Washington State Regional Haze State Implementation Plan

Appendix A

Western Regional Air Partnership Consultation Process

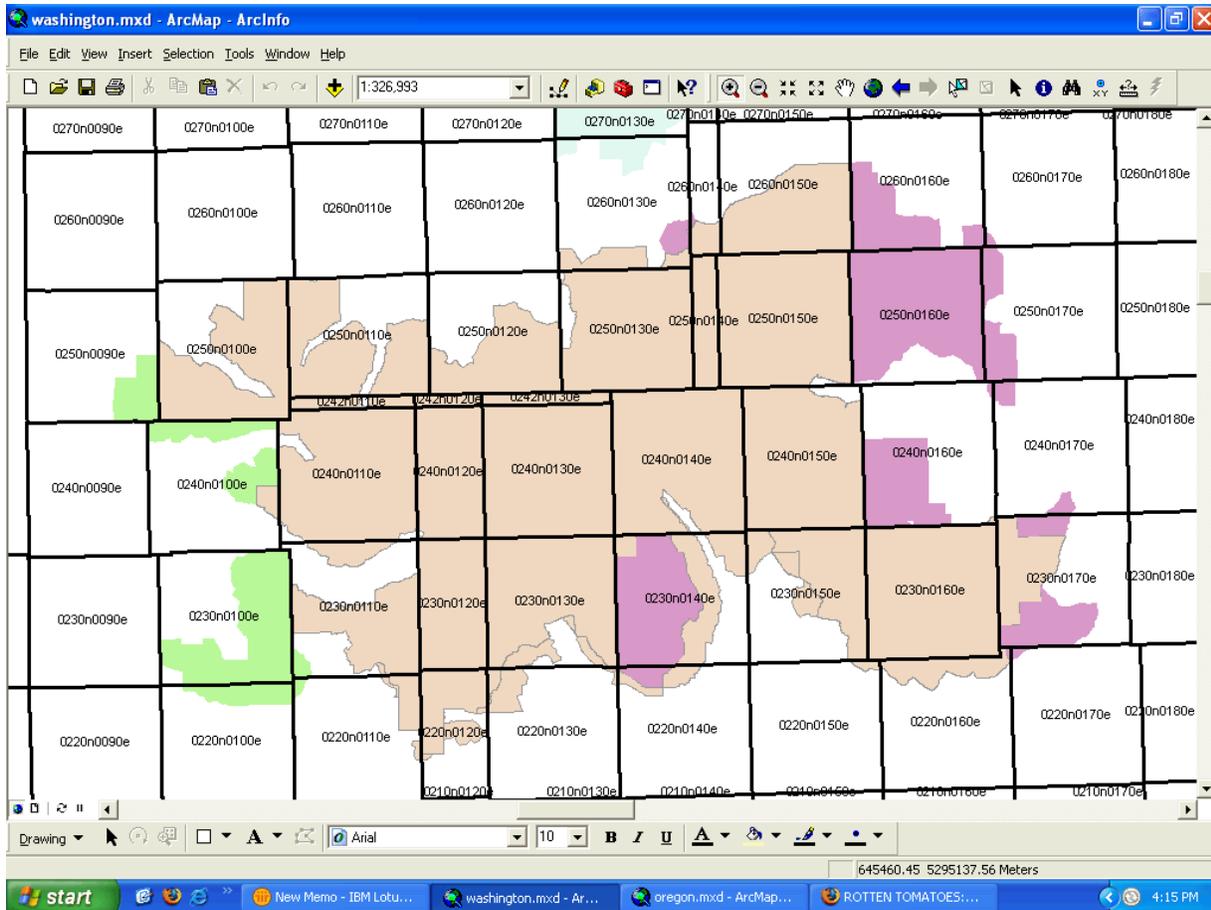
The USDA-FS notes that there is an incorrect sentence in Chapter 4 and the map of the Alpine lakes wilderness in Figure 4-4 is incorrect and provides Ecology with an updated map for use.

The map you are using for Alpine Lakes wilderness is incorrect (Figure 4-4). Below is the correct extent of the wilderness. We will be happy to assist you in getting the correct boundaries for this wilderness.

Ecology has removed the questioned sentence from Chapter 4. We revised Figures 4-1 and 11-1 showing the boundaries of the Alpine Lakes Wilderness. Figure 4-4 is from Causes of Haze Assessment Descriptive Maps and we are unable to revise this figure.

Figure I-2 Sample wind field (5 am on Jan 5, 2003. The ten small black squares show points where there is a significant difference in direction between the 4-km (blue barbs) and 0.5-km (red barbs) wind fields. The large black rectangle outlines the area shown in greater detail in Figure 3.

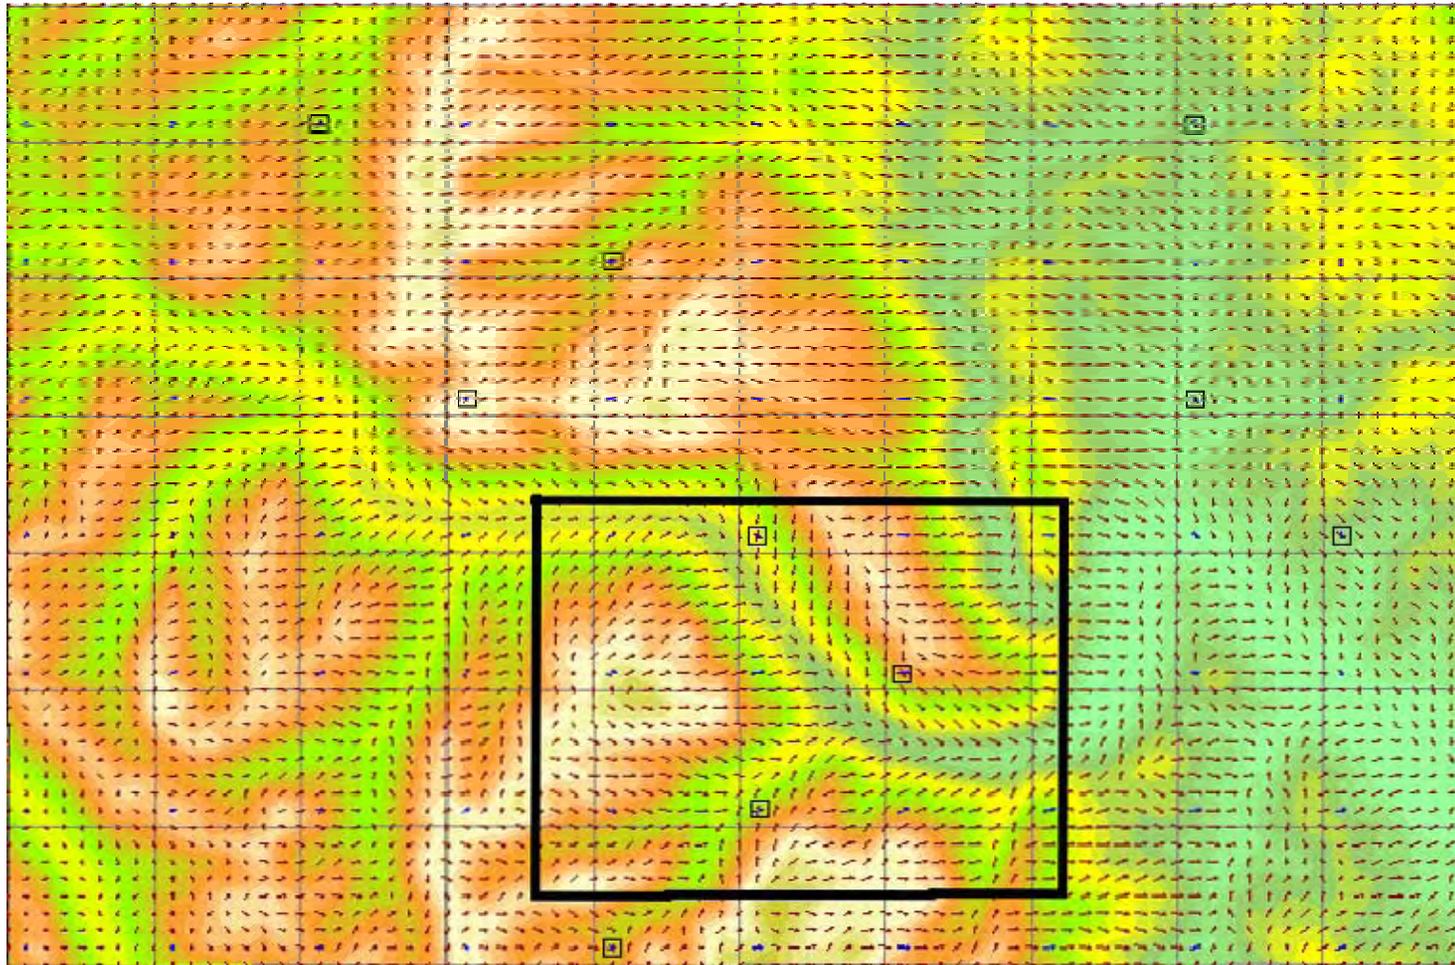
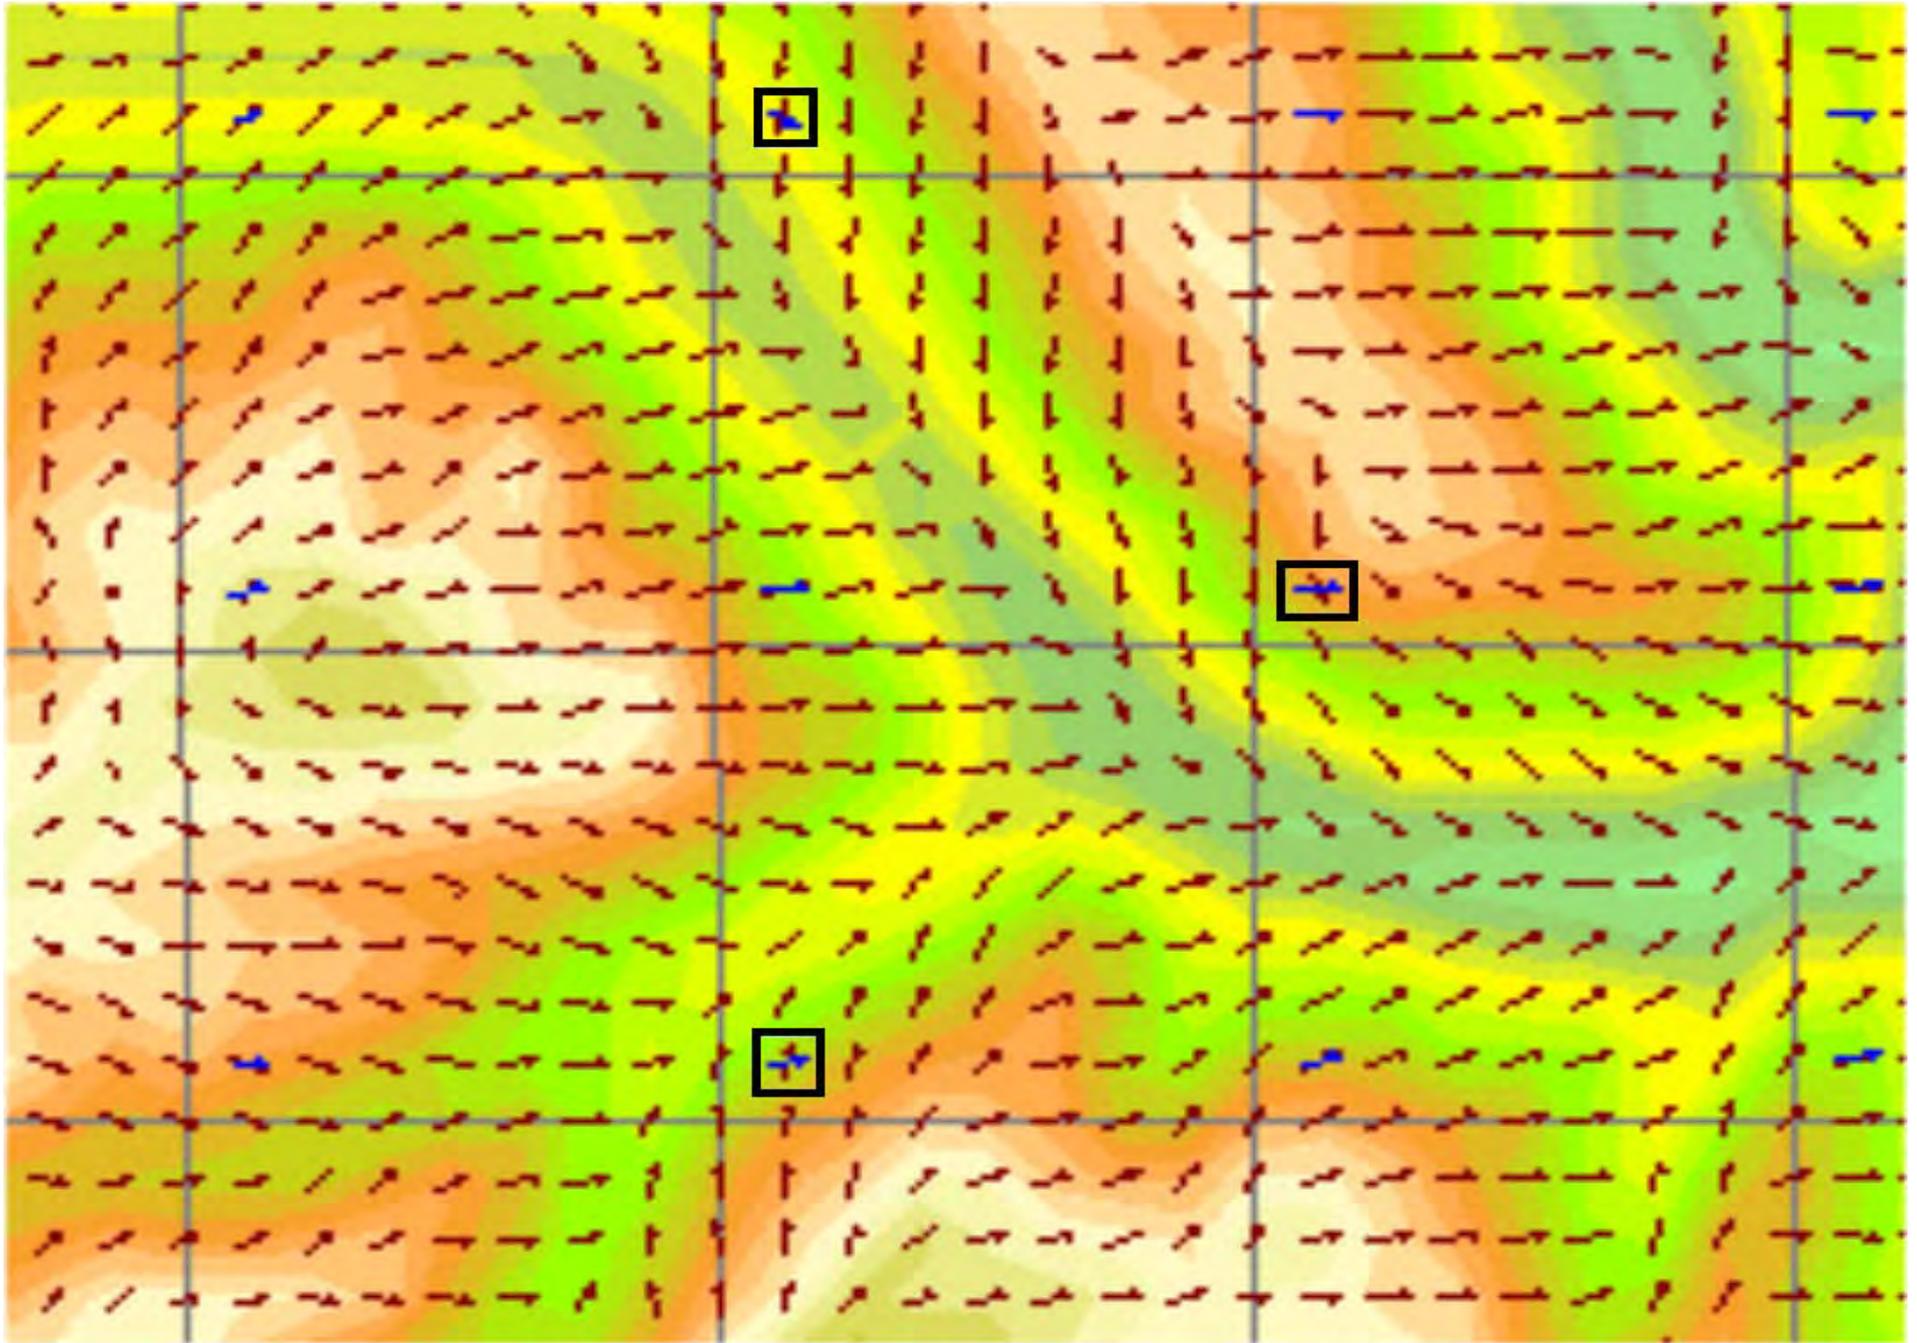
One of the key contentions made by Ecology is that use of the 4-km CALMET generated wind field creates "errors" in the surface wind field, which are resolved by use of the 0.5-km wind field. This is demonstrated in Figure I-2 and I-3 in which both the 4-km and 0.5-km surface winds are shown with the 0.5-km resolved terrain as background. Ecology states "*...the finer resolution modeling provides a much more detailed spatial pattern in the winds which conforms more accurately to the terrain when compared with the wind fields from the lower resolution model runs. It is clear from these plots that the lower resolution runs will miss much of the terrain channeling within the modeling domain. More important, the failure of the 4-km grid to accurately represent peaks will allow air to flow unimpeded through regions that would otherwise deflect it.*" In examining the validity of this statement, we note the following.
